Lincoln Fields Secondary Plan Document 10 – Consultation and Circulation Details

Table 1: Changes to the Lincoln Fields Secondary Plan from August 2024 to November 2024

Extract from Map 3 of the Parks and Recreation Facilities Master Plan (2022)

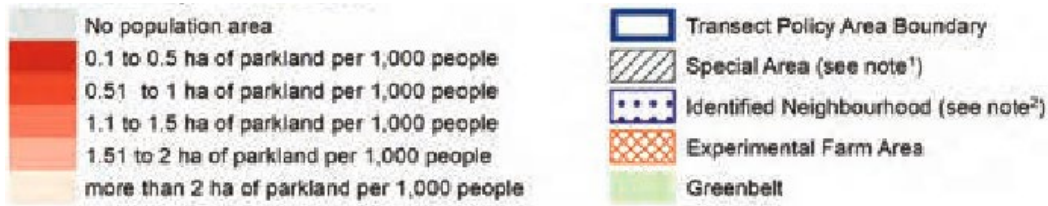
- Residents of Woodpark and the Woodpark Community Association have expressed a significant lack of parkland and greenspace within and near Woodpark and had hoped that the Lincoln Fields Secondary Plan would secure a new park for their community.

- The [City's Park and Recreation Facilities Master Plan \(2022\)](#) indicates that Woodpark has a parkland rate of 0.51 to 1 hectares of parkland per 1,000 people (see below extract). The Parks and Recreation Facilities Master Plan identifies that there is a lack of parkland for the Woodpark neighbourhood and that this community is not at the targeted 2 hectares of parkland per 1,000 people.
